UN Regulation No. 131

Uniform provisions concerning the approval of motor vehicles with regard to the Advanced Emergency Braking System (AEBS) for M₂, M₃, N₂ and N₃ vehicles

Figure 2:
Right turn or left turn of a forward vehicle

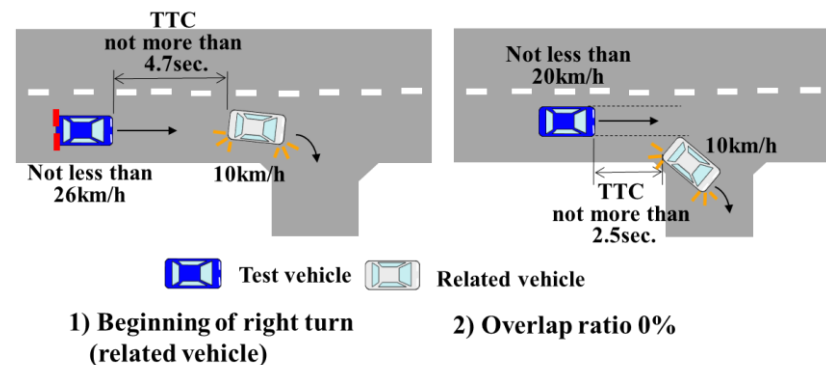
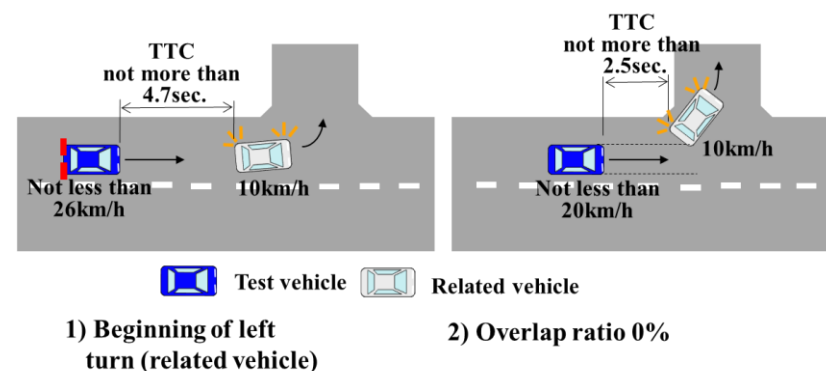
The blue car needs to be changed from passenger vehicle to large vehicle.

Figure 4:
Lane change due to road construction

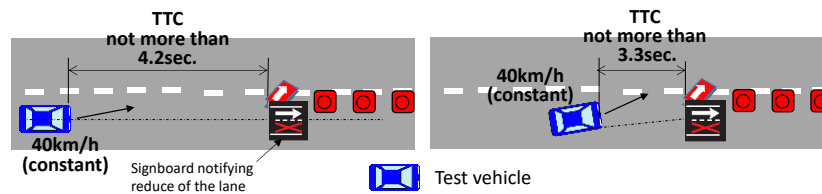
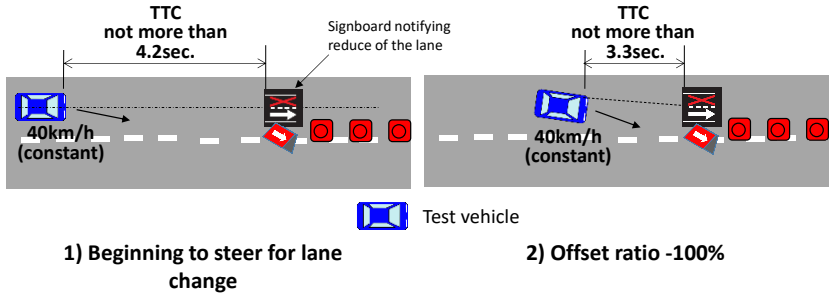
The blue car needs to be changed from passenger vehicle to large vehicle.
